Subject: Docket No. 50-206
Provisional Operating License No. DPR-13
Amendment No. 77
San Onofre Nuclear Generating Station
Unit 1

By letter dated April 18, 1979, we submitted Amendment No. 77 in Docket No. 50-206. Amendment No. 77 consists of Proposed Change No. 77 to the Technical Specifications incorporated in the above-numbered license. Proposed Change No. 77 reflects San Onofre Unit 1 and corporate reorganization changes.

FIGURE 5.2-1 SOUTHERN CALIFORNIA EDISON COMPANY CORPORATE ORGANIZATION

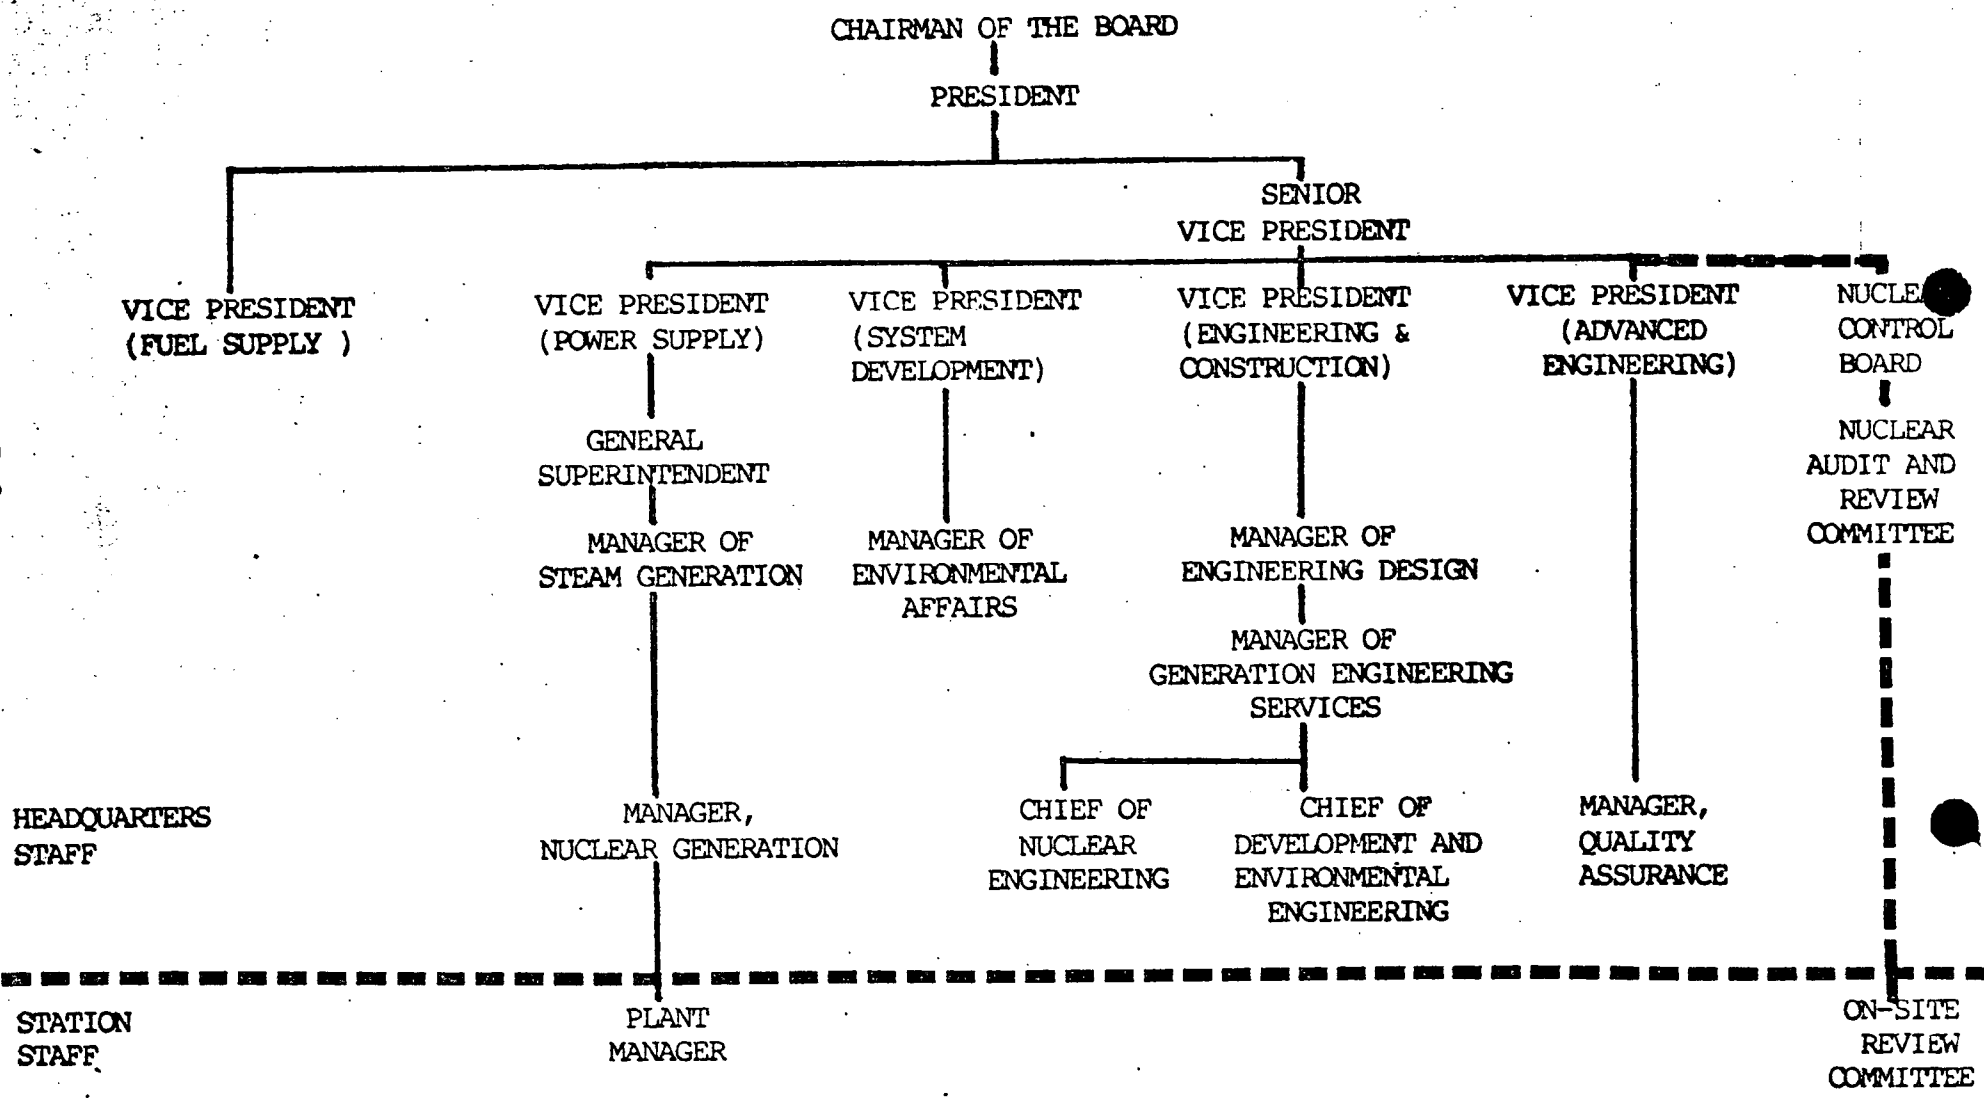
The corporate reorganization changes are reflected in Figure 6.2.1.1 (Appendix A Technical Specifications) and Figure 5.2-1 (Appendix B Environmental Technical Specifications) of Proposed Change No. 77. In order to incorporate a recently announced corporate level organization change, these figures have been revised to reflect a change in reporting relationship between the Vice President (Power Supply) and Senior Vice President. In addition, the figures reflect a change in the reporting relationship between the Nuclear Control Board and the Senior Vice President.

Enclosed are forty copies each of revised Figures 6.2.1.1 and 5.2-1 which supersede the corresponding figures of Proposed Change No. 77. In accordance with Technical Specification requirements, the enclosed figures have been reviewed and approved by the San Onofre Unit 1 review committees and are incorporated into and made a part of Proposed Change No. 77 herein by reference.
